Re: S/D 80-104 - Final plat of Brad Boone Addition

At the regular meeting of the Subdivision Committee of the Metropolitan Area Planning Commission on February 5, 1981, the above-captioned plat was considered. The action of the Committee was to recommend that this plat be approved, subject to:

Re: S/D 80-104 - Preliminary plat of Brad Boone Addition

SUBDIVISION REPORT

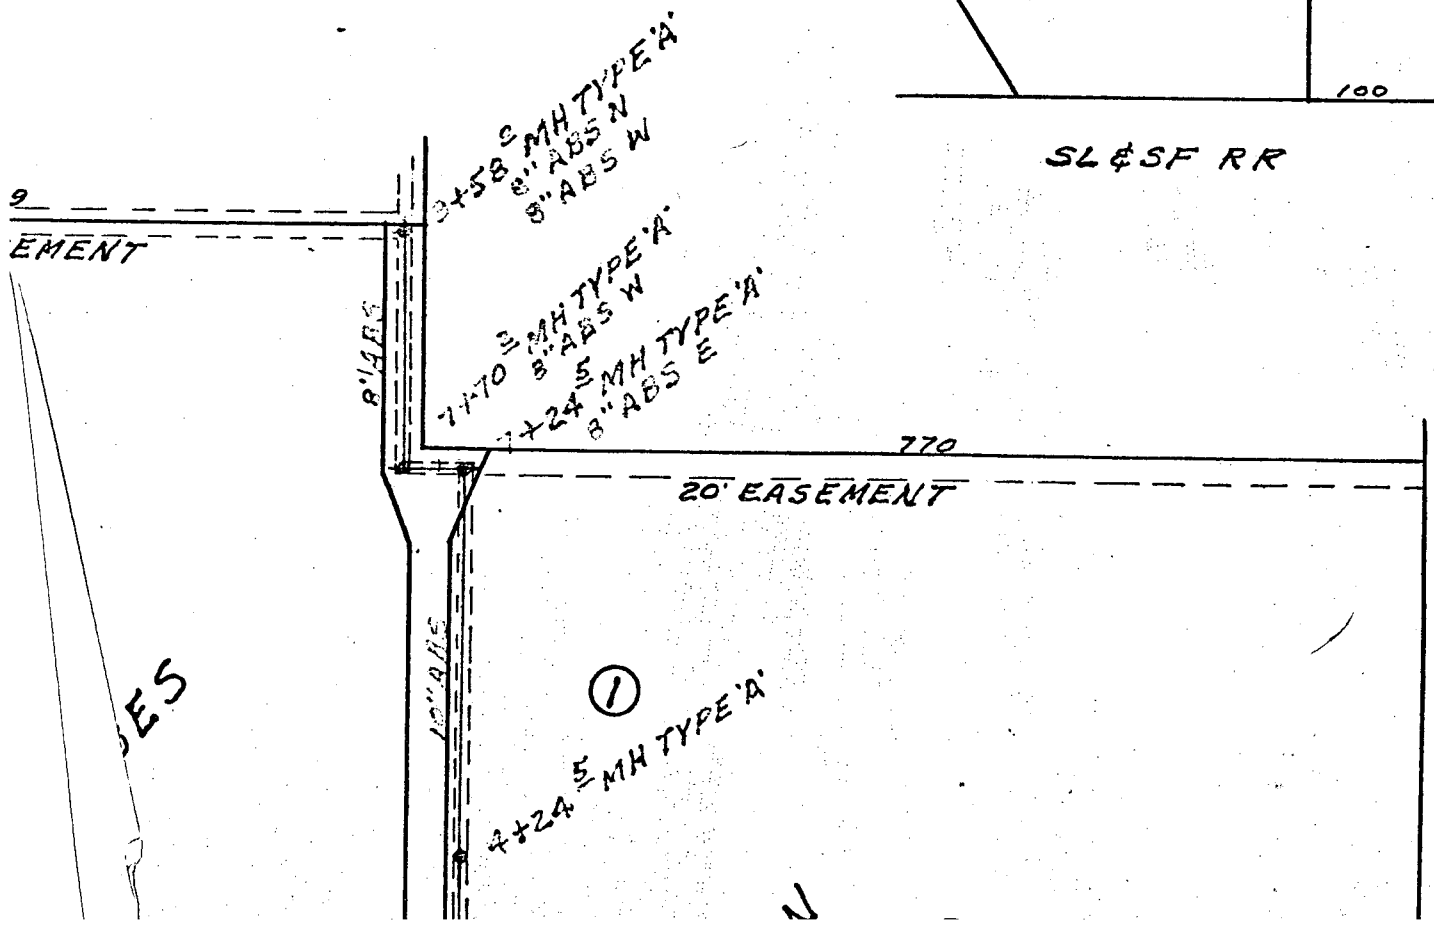
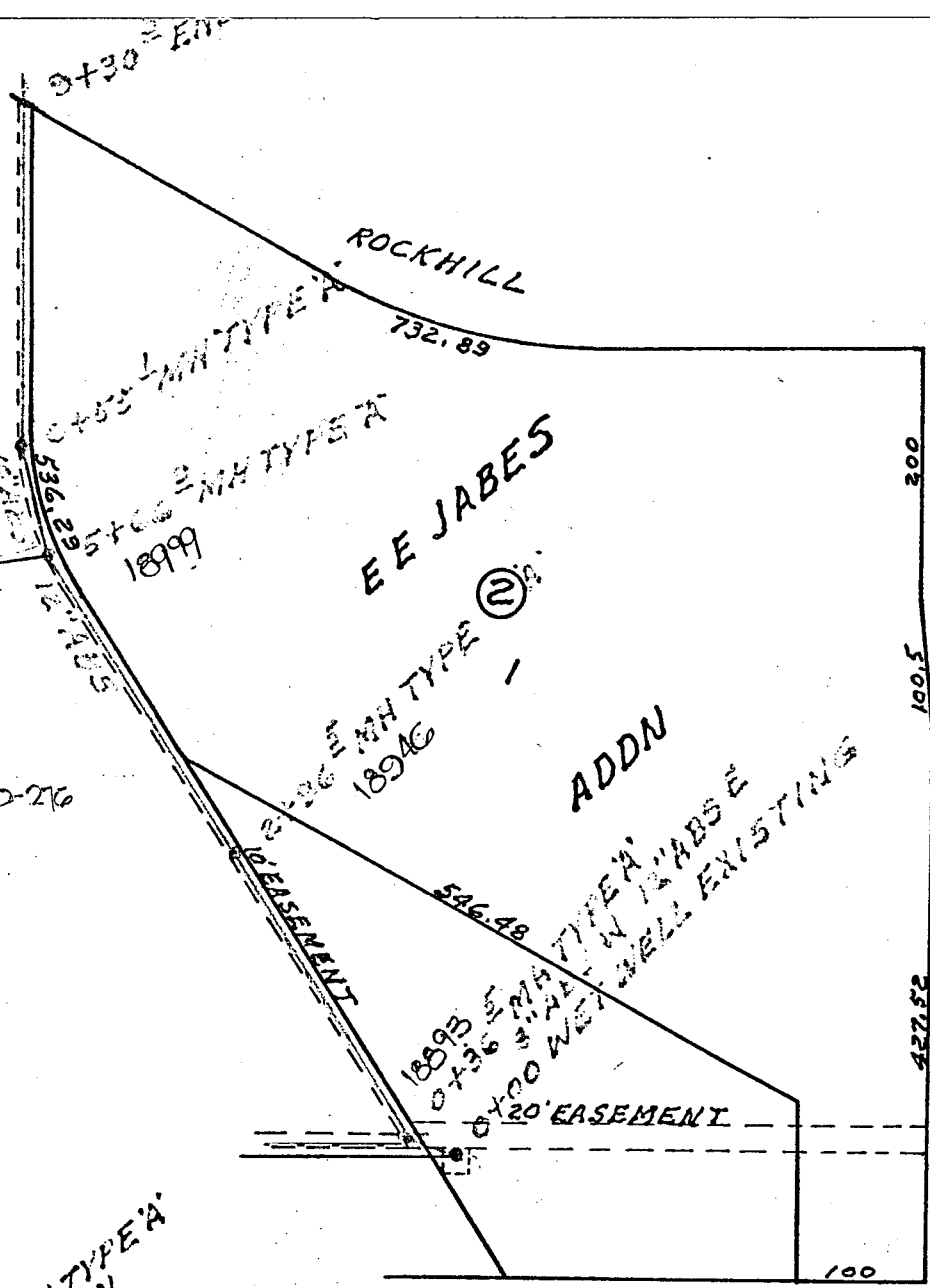
DRAINAGE AREAS -

①. $A = 3.1$ ACRES $C = 0.90$ $I_{100} = 8.98$ W/HR
 w to c 15mm.

$$Q_{100} = (0.90)(8.98)(3.1) = 25 \text{ cfs.}$$

AREA IS TO BE DRAINED BY A 30" PIPE @ 0.40% SLOPE INTO THE EXISTING DRAINAGE DEDICATION ADJACENT TO THE WEST OF THIS PLAT.

DRAINAGE WILL BE COLLECTED BY A BEEHIVE INLET IN A SWALE ALONG THE REAR LOT LINES.

USE A V-SHAPED CHANNEL W. A 15' DEPTH AND 5:1 SIDE SLOPES. TOTAL SWALE WIDTH NEEDED IS 15'.

NOTE. - AS A PROTECTION, THE ELEVATION OF THE BEEHIVE SHALL NOT BE MORE THAN 2 FEET BELOW THE ELEVATION OF THE TOP OF THE DRAINAGE DITCH TO THE WEST. THIS WILL PROVIDE ESCAPE FOR DRAINAGE AT SUCH TIMES WHEN THE BEEHIVE IS CLOGGED.
